## Product Change Notification

### PCN-PCC-8043-2022

Business Unit	Product Line Code	Type of Change	Action	Date of Issue
PCC - PCB Connectors	AAC	Product Change Notification	Notify Distributors and Field	7/18/2022

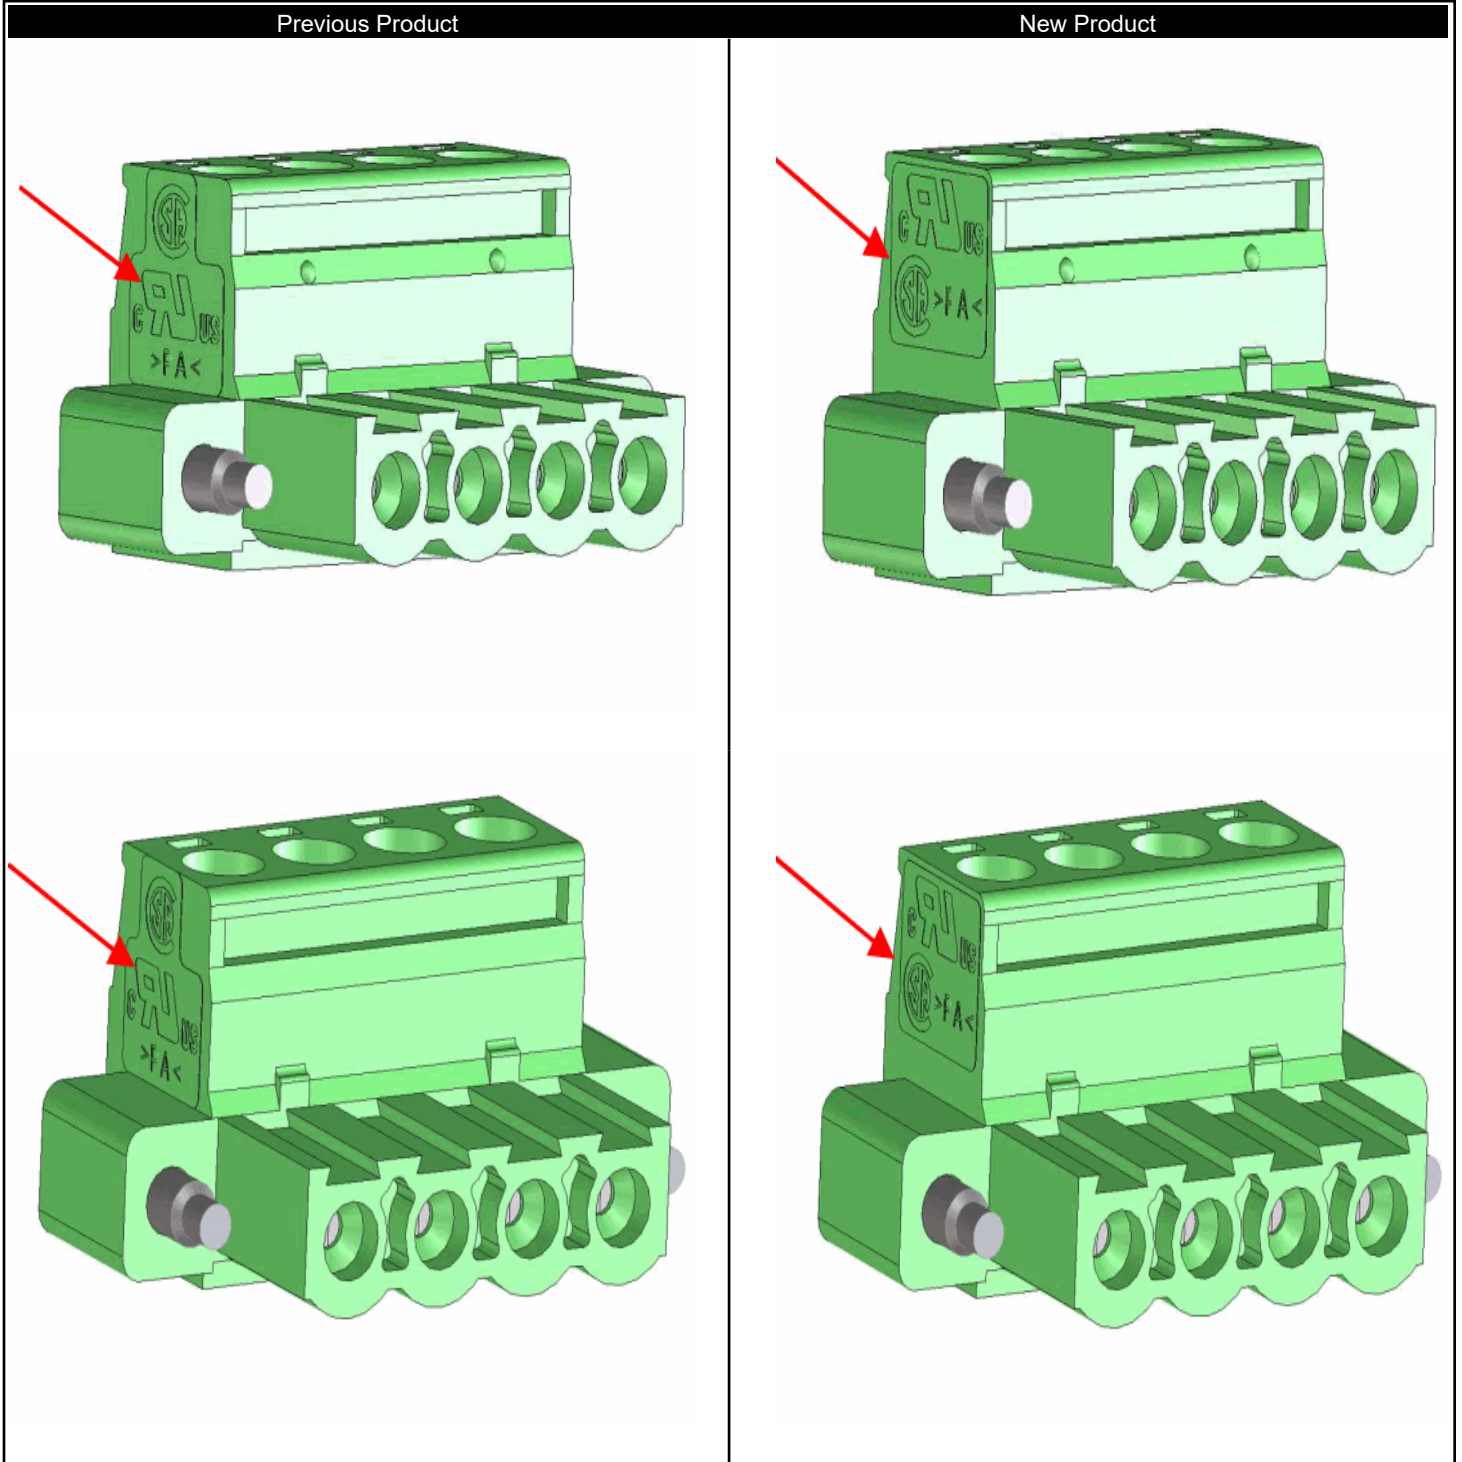
Description for Product Change Notification
The construction of new injection molding tools for MSTB 2,5/...-STF with 2-position through 8-position will be used to adapt the lettering fields to match the design used by other MSTB 2,5/...-ST connector families. A visual comparison of old / new is provided below within this document. The external dimensions, technical data, and approvals remain unchanged. The existing tools will continue to produce the old lettering field. This will gradually be replaced with the new version over the coming years.
